ADDENDUM No. 1

RFP No. 26-02

E. Huron River Drive Retaining Wall Replacement and Road Reconstruction

SCALE PLAN: 1" = 20'
DRAWING No. AA23004-5
SHEET No. 5 OF 13

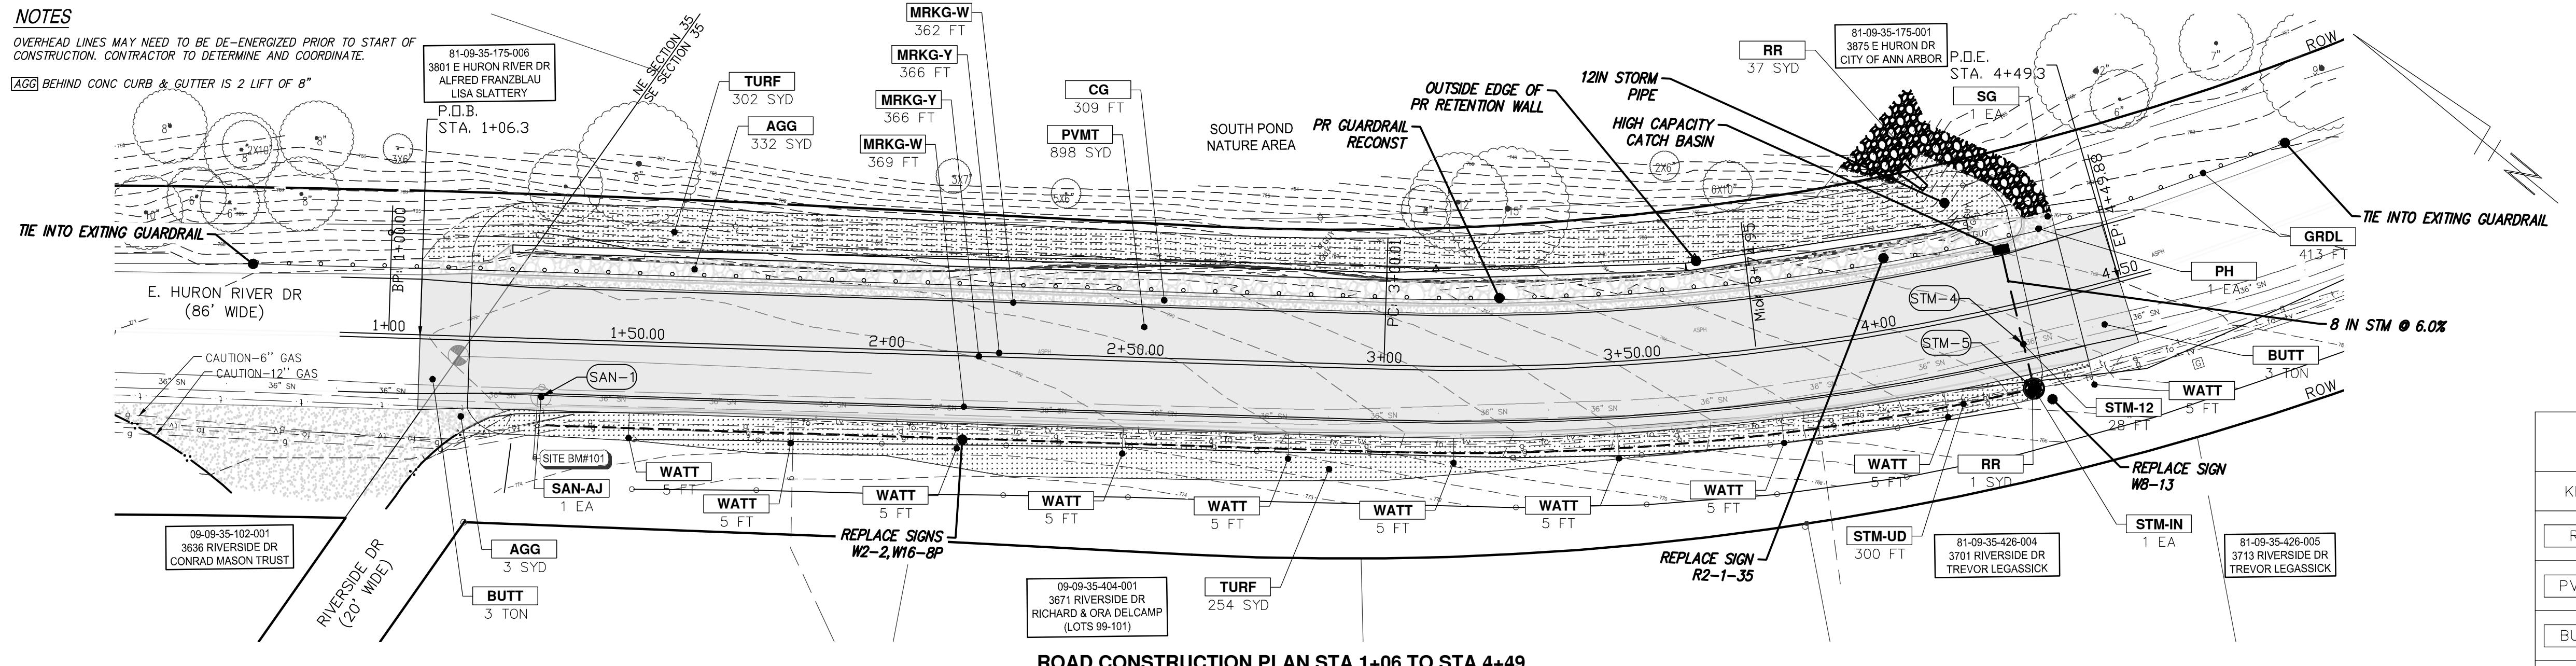
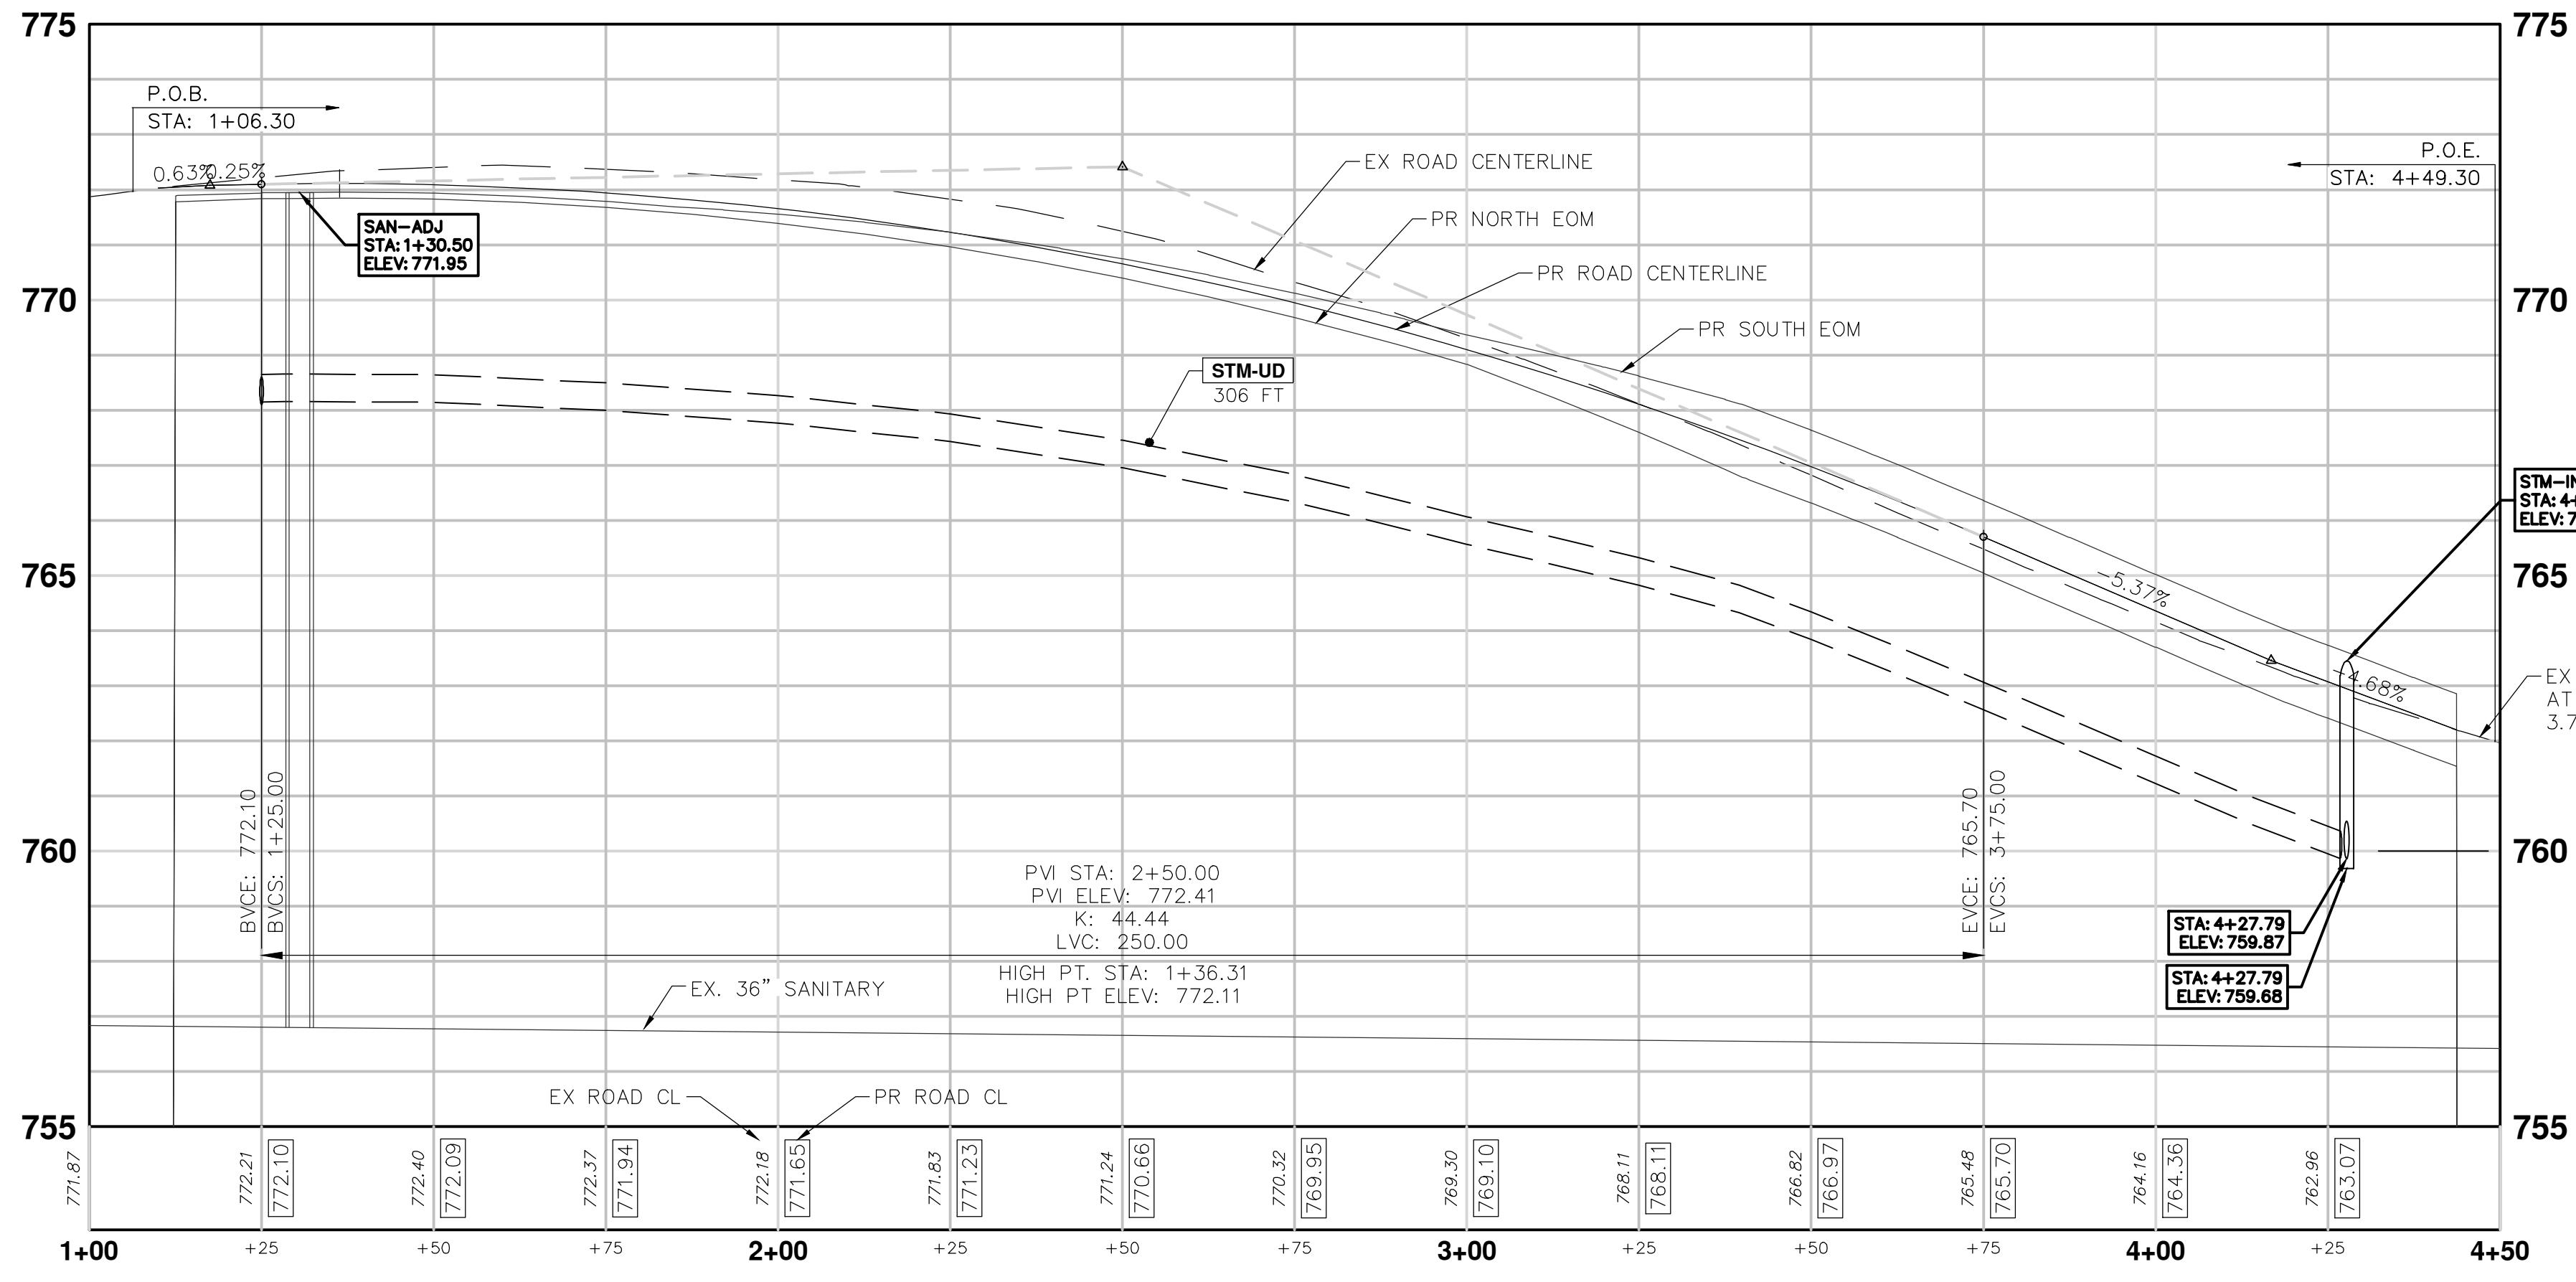
Sheet 5: guardrail keynote and pay item from reconstruct to remove and quantity increased

SCALE PLAN: 1"=60'	E. HURON RIVER DRIVE RETAINING WALL REPLACEMENT AND ROAD RECONSTRUCTION RIVERSIDE DR TO CHALMERS RD MAINTENANCE OF TRAFFIC PLAN
DRAWING No.	
SHEET No.	
AA23004-8	
8 OF 13

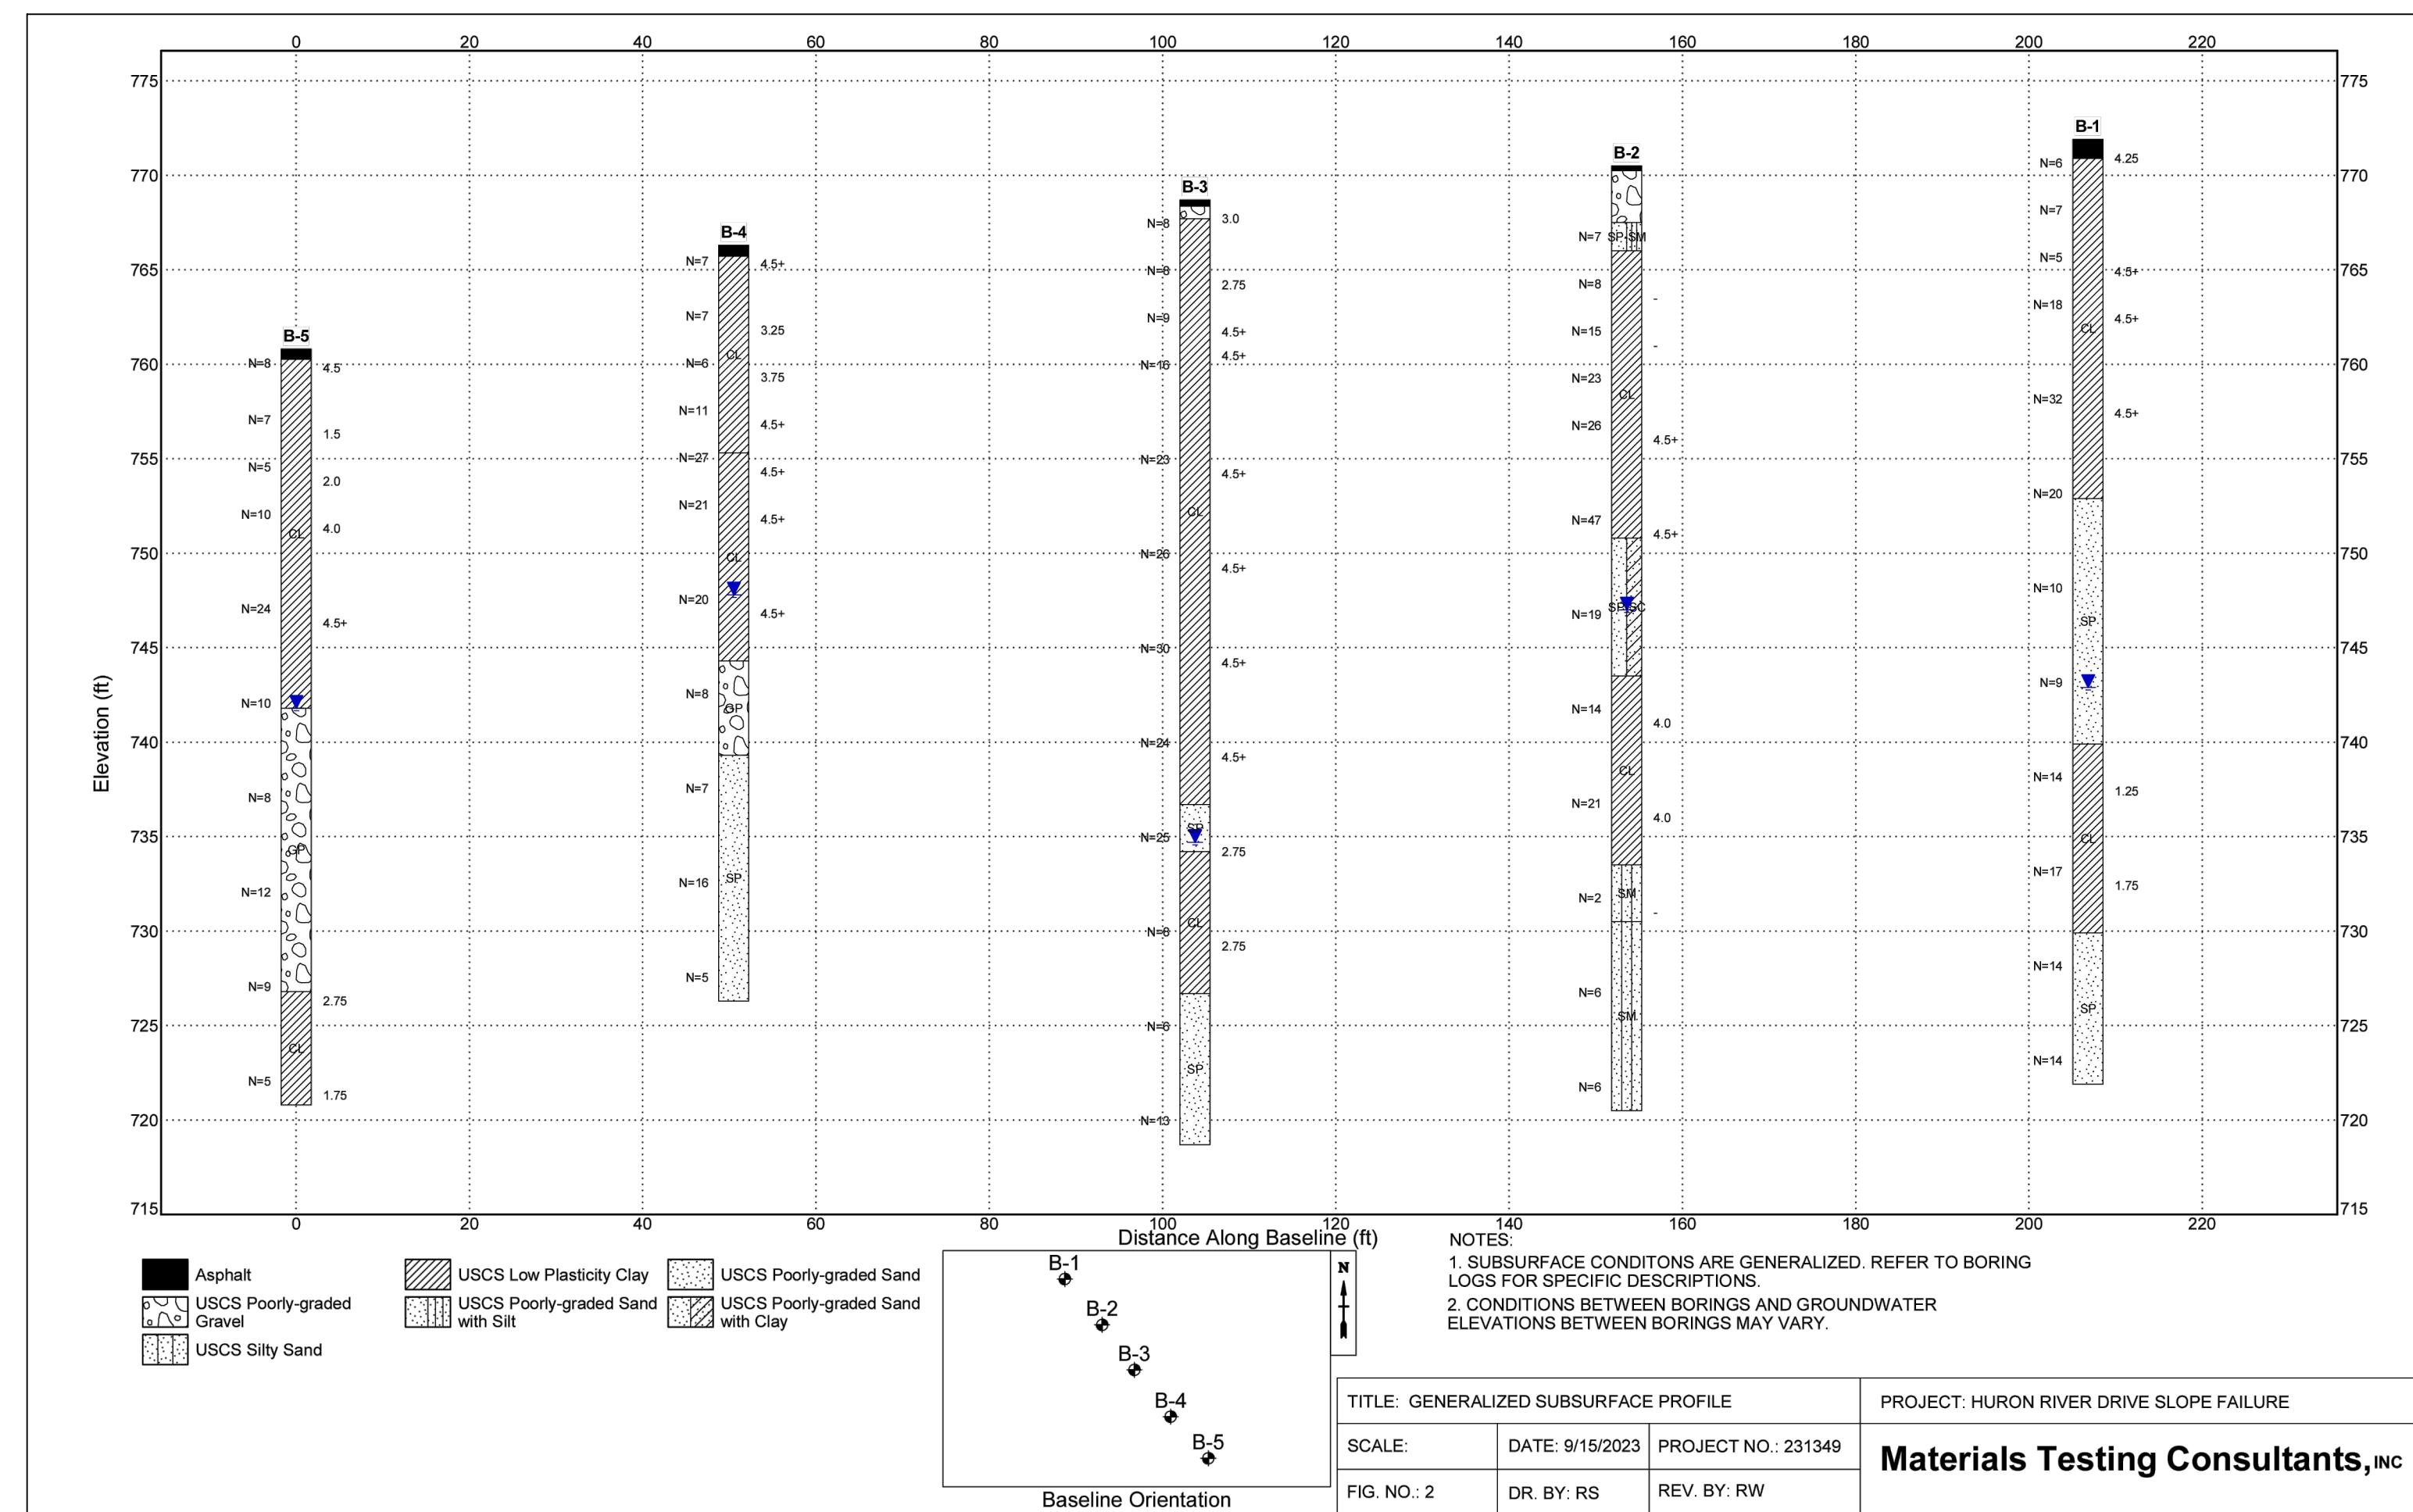
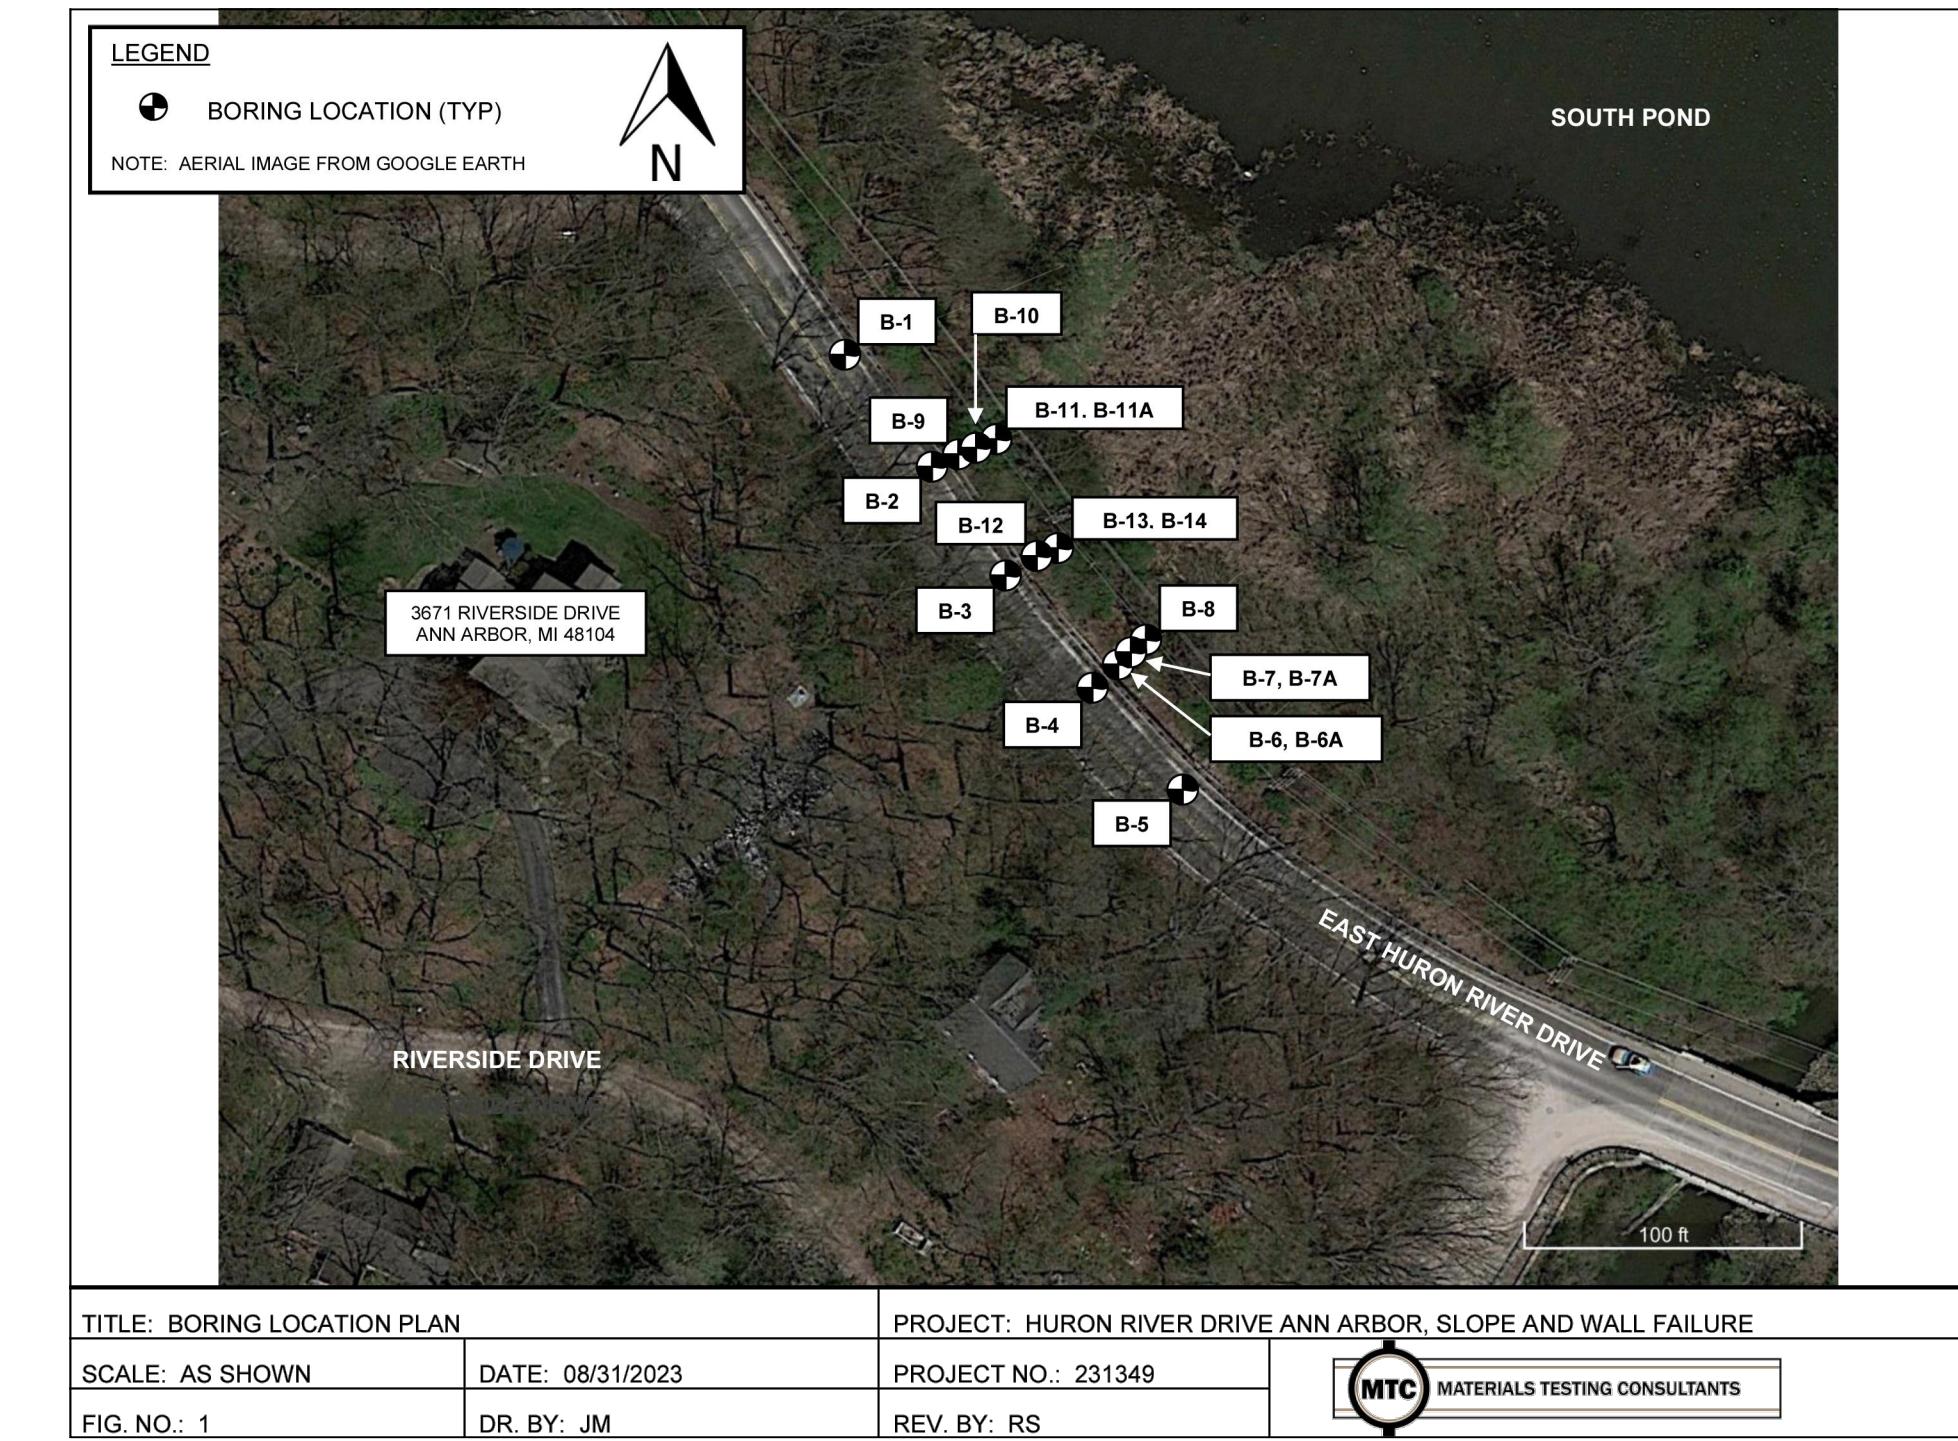
Sheet 8: portable,changeable message boards added
